STAFF REPORT
KETCHUM PLANNING AND ZONING COMMISSION
REGULAR MEETING OF FEBRUARY 18, 2026

PROJECT: Lift View Townhomes

FILE NUMBER: P25-038 & P25-041

APPLICATION TYPE: Design Review and Townhouse Subdivision Preliminary Plat

Rendering

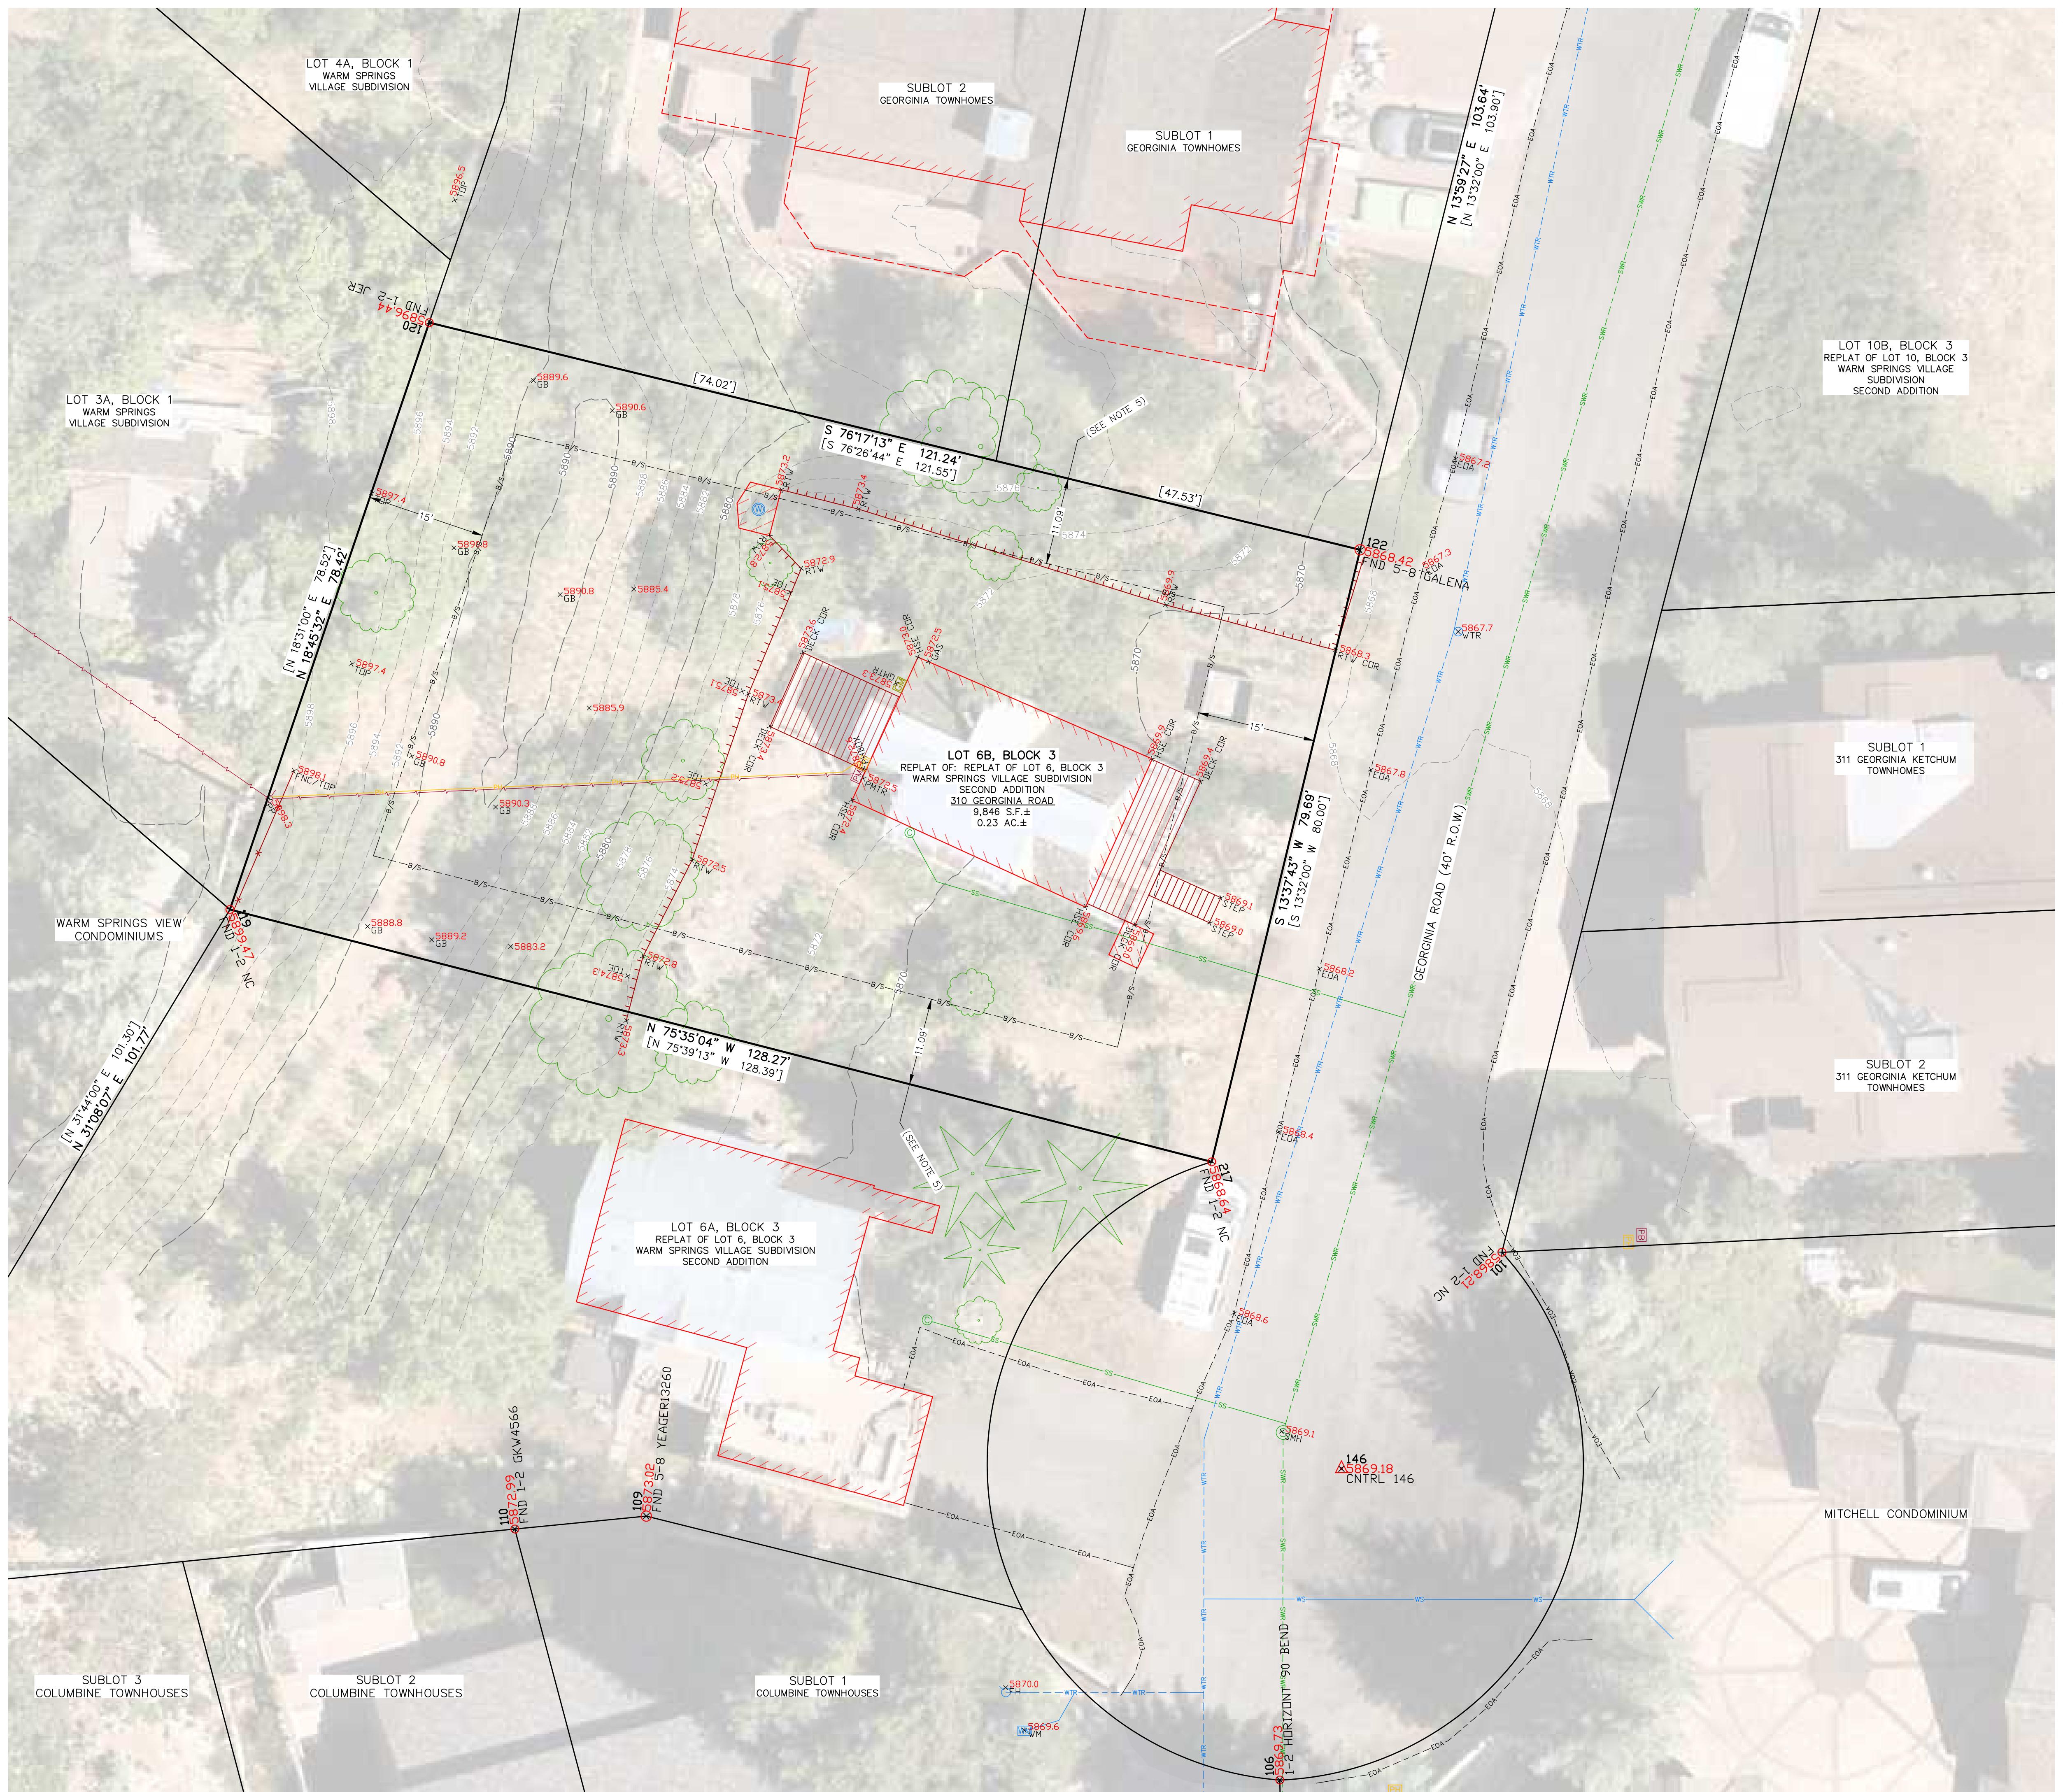
The proposed development includes two attached townhomes which are identical and utilize mountain modern design (see figure 2 below for a rendering of the project). The applicant made the following design changes to provide more undulation and relief to the front façade:

- Added horizontal bands that overhang the second and third floors
- A recessed step added to the roof line fascia
- Stepped back third floor 2' from front façade
- Changed the color gradient of materials on the front façade from dark (Merrillstone Montana Mossy Stone) on the bottom to the beige stucco at the top to give the structure a more grounded appearance.

Staff believes these changes help add visual interest and reduce the bulk of the duplex at the front façade, however, staff still find that the overall structure presents a tall, minimally varied wall plane with little relief of the massing. While the second-floor steps back 7 feet from the ground floor, the effectiveness of the 7-foot step back at the second floor is diminished as the third floor projection above completely covers the recession created by the second-floor patio. Staff does acknowledge that the units are offset from each other by 5 feet at all three floor levels which helps break up the horizontal wall plane of the duplex's front façade. However, staff find that the proposed flat roof further accentuates the overall massing and horizontal emphasis of the structure, contributing to the boxy appearance. In addition to the flat roof form, the pronounced metal fascia in contrast to the beige stucco appears top-heavy and exacerbates the duplex's boxy appearance. Without variation in roof form or increased wall undulation on the third story, the design lacks articulation that could otherwise help break down the building's scale and reduce its perceived bulk. Staff requests the Commission to review the proposal and provide feedback on whether the project sufficiently incorporates architectural features and if it adequately reduces the appearance of bulk and flatness.

SHEET #:
L1

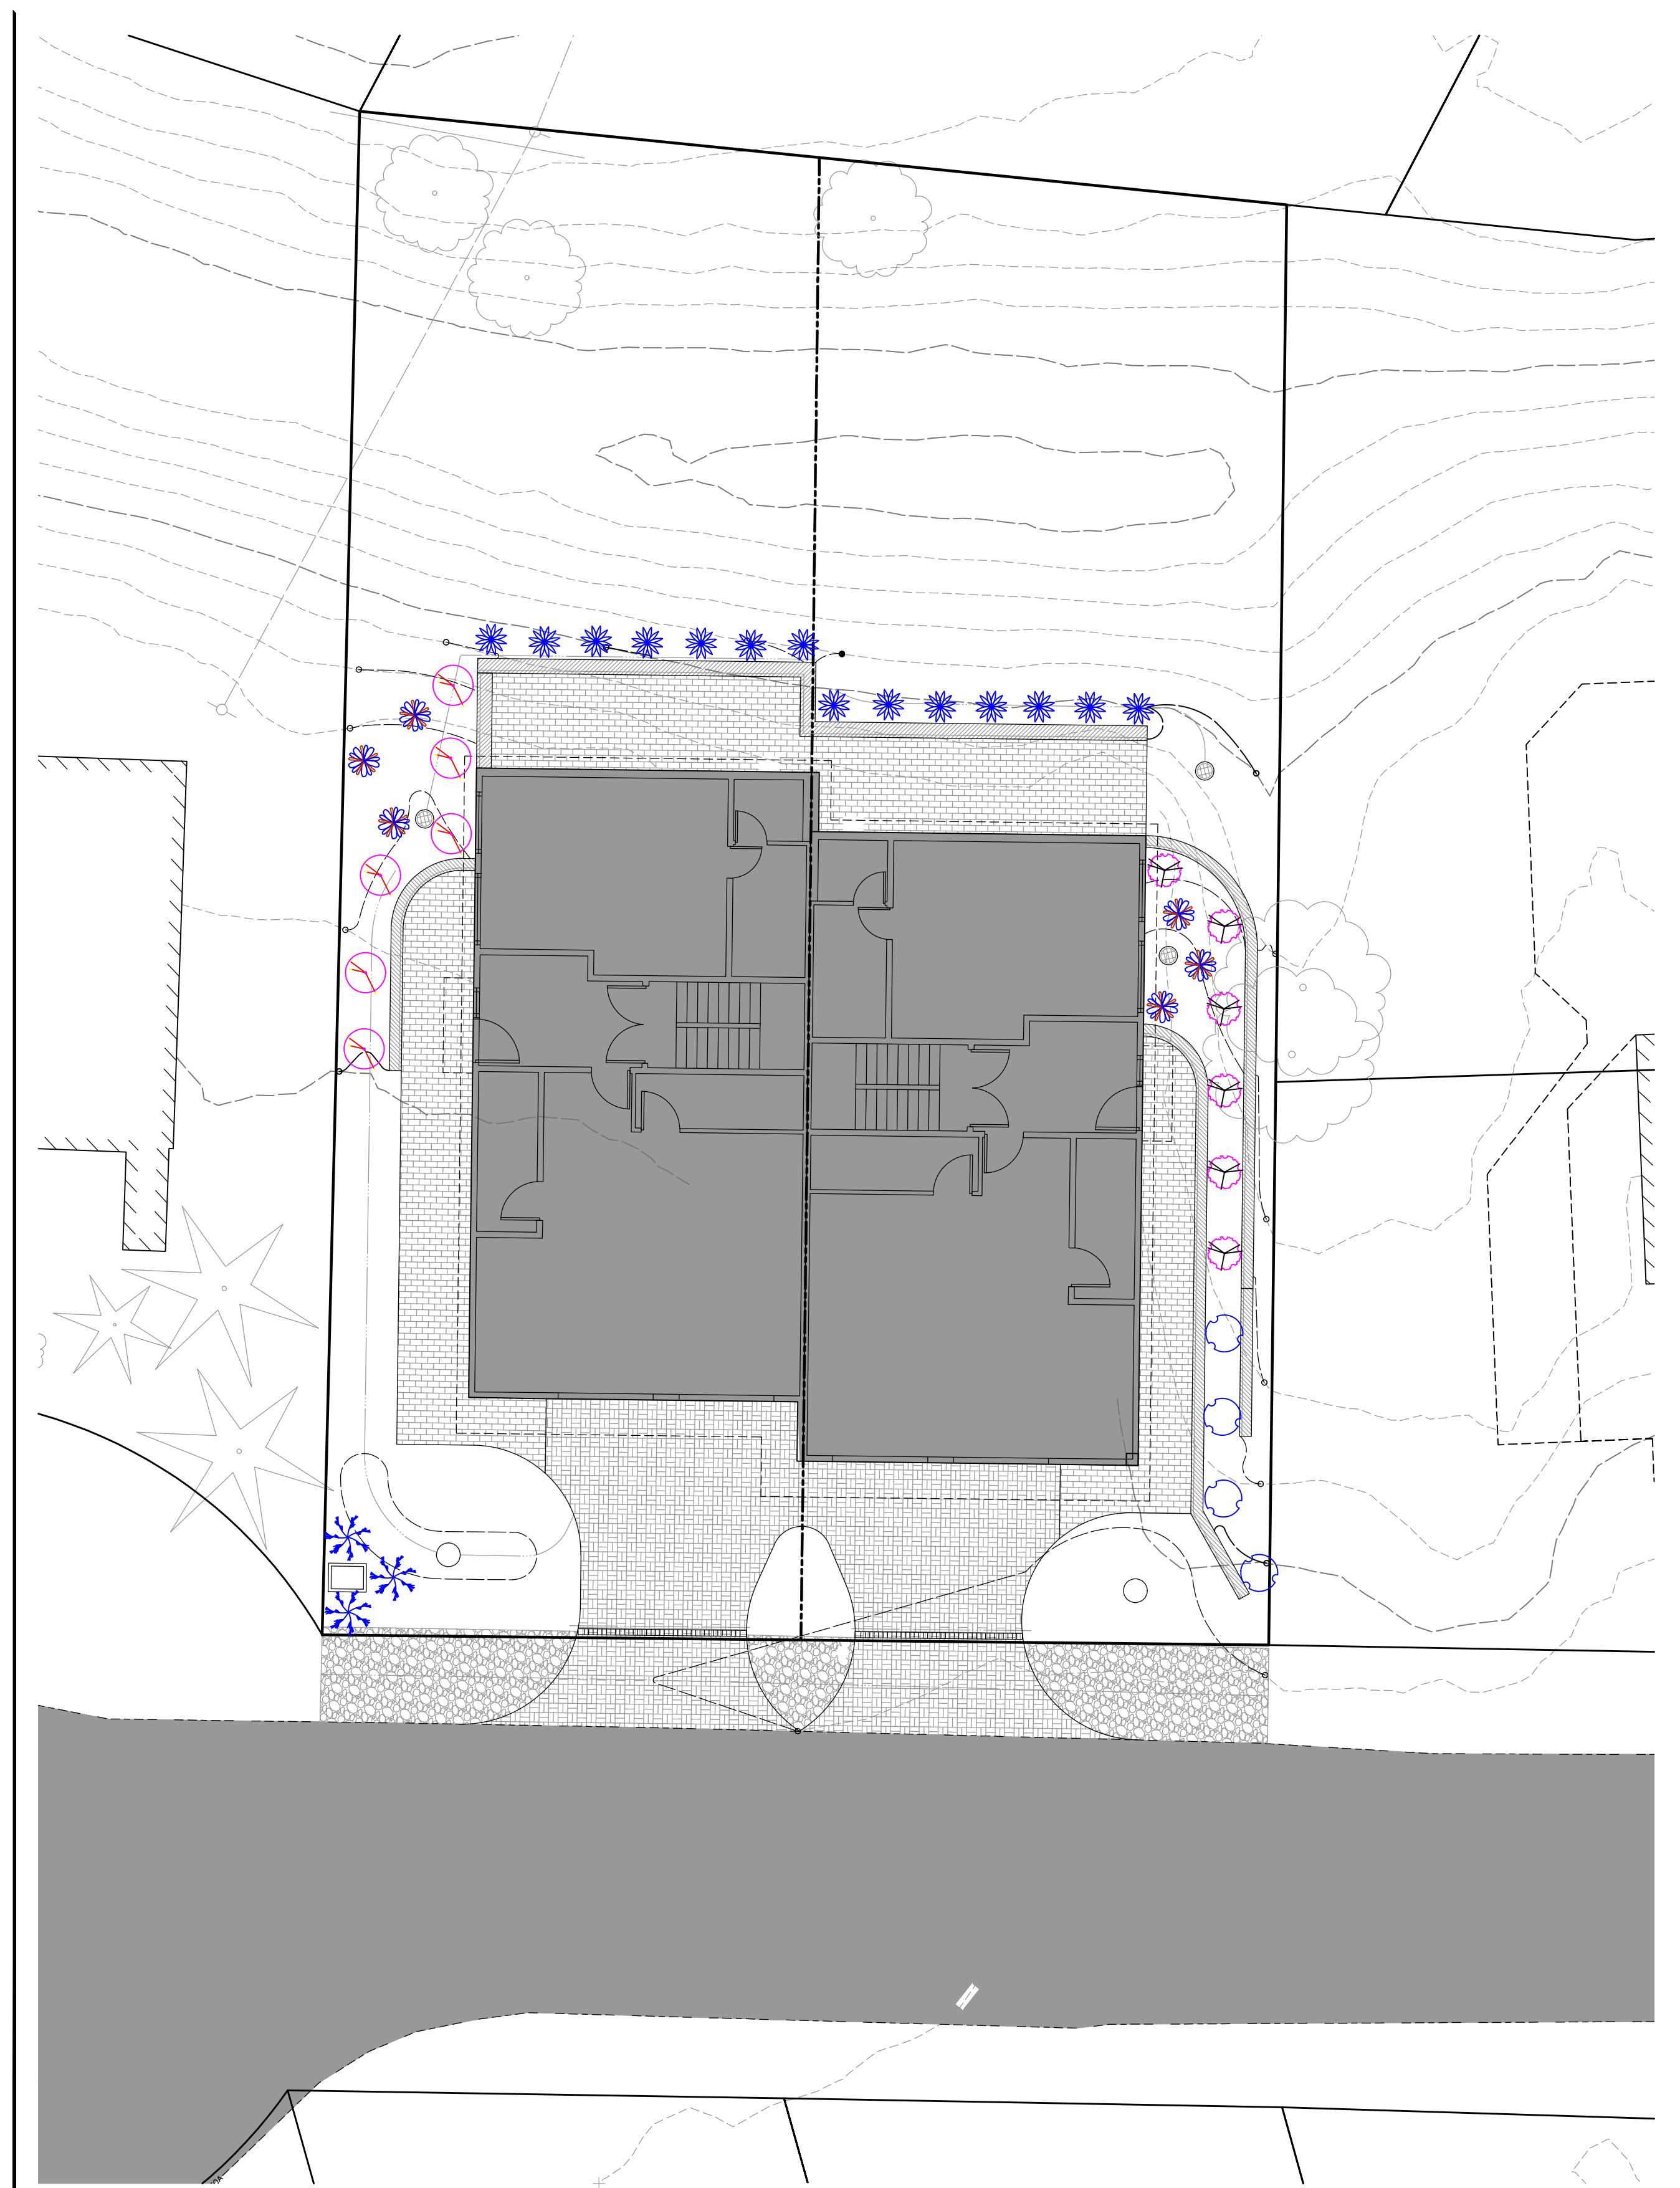
The landscape plan submitted with the application materials underwent a few rounds of revisions during department review to select species that were drought tolerant and offer sufficient screening for the retaining walls that are visible from the street. However, the plant legend on the landscape plan continues to lack all of the proposed plant species, including for both groundcover and reseeding. All species must be indicated on the landscape plan for staff to verify drought tolerance. Staff recommend condition of approval #3 which stipulates that the applicant shall provide a final landscape plan that indicates all proposed plant species and the drought tolerance of each species that is to be reviewed and approved prior to building permit issuance.

| 17.96.060.I.1 – Landscaping | Conformance |
|---|-------------|
| Finding: Landscaping has been provided for the project as indicated on Sheet L1 of the project plans. As mentioned above, the landscape plan underwent a few rounds of revisions during department review to select species that were drought tolerant and offer sufficient screening for the retaining walls that are visible from the street. However, the plant legend on the landscape plan continues to lack all of the proposed plant species, including for the screening of utilities, groundcover, and reseeding. All species must be indicated on the landscape plan for staff to verify drought tolerance. Staff recommend condition of approval #3 which stipulates that the applicant shall provide a final landscape plan that indicates all proposed plant species and the drought tolerance of each species that is to be reviewed and approved prior to building permit issuance. | |

3. A final landscape plan shall be provided for review and approval prior to building permit issuance. Said landscaping plan shall provide a detailed plant list indicating all proposed plant species and the drought tolerance of each species.
